Access Compliance Report

Public Rights-of-Way

(Curb Ramps)

Intersection ID: 31257	Main Street: EWEN_CR	Cross Street: SACKETT_WY	Location: NW
ADA ID: A2E83E7B34A2	Ramp Type: PerpDiag	Initial Pass/Fail: Fail	Overall Compliance: No
		Severity Score: 10

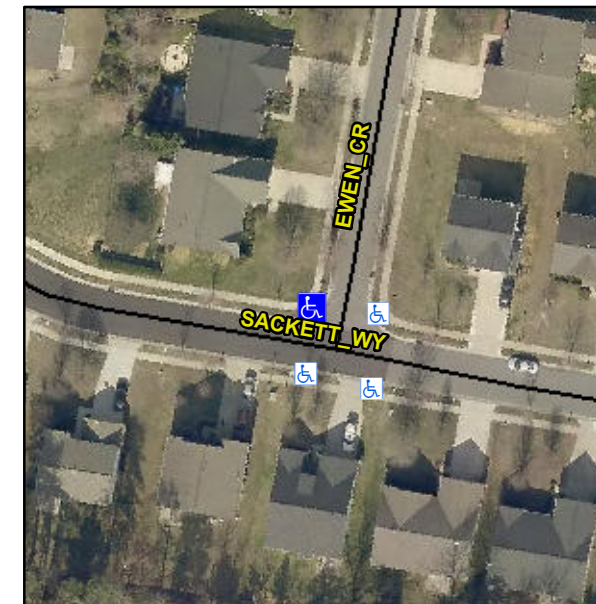
Not Found, R304.5.1, R304.5.3

Compliance	Description	Data	Compliance	Description	Data
N/A	Ramp Length (in)	52.0	Yes	Ramp Slope (%)	5.0
No	Ramp Width (in)	40.5	No	Ramp XSlope (%)	2.1
N/A	Flare Type LT	N/A	N/A	Flare Type RT	N/A
N/A	Flare Slope LT (%)	N/A	N/A	Flare Slope RT (%)	N/A
N/A	Flare Traversable LT?	N/A	N/A	Flare Traversable RT?	N/A
N/A	Landing Length (in)	N/A	N/A	DWS Provided?	N/A
N/A	Landing Width (in)	N/A	N/A	DWS Contrast?	N/A
N/A	Landing Slope (%)	N/A	N/A	DWS Length (in)	N/A
N/A	Landing X Slope (%)	N/A	N/A	DWS Full Width?	N/A
N/A	Landing Curb? (Y/N)	N/A	N/A	DWS Offset (in)	N/A
N/A	Shared Landing?	N/A			
N/A	Gutter Ponding?	N/A	N/A	Gutter Slope (%)	N/A
N/A	Gutter Lip Ht (in)	N/A	N/A	Gutter X Slope (%)	N/A
N/A	Painted X Walk1?	No	N/A	Painted X Walk2?	No
	X Walk 1 Direction	To S		X Walk 2 Direction	To E
N/A	X Walk 1 Width (in)	N/A	N/A	X Walk 2 Width (in)	N/A
	X Walk 1 Slope (%)	0.7		X Walk 2 Slope (%)	3.9
	X Walk 1 X Slope (%)	5.1		X Walk 2 X Slope (%)	1.4

Remove & Replace Curb Ramp With Two New Directional Ramps or Equivalent.
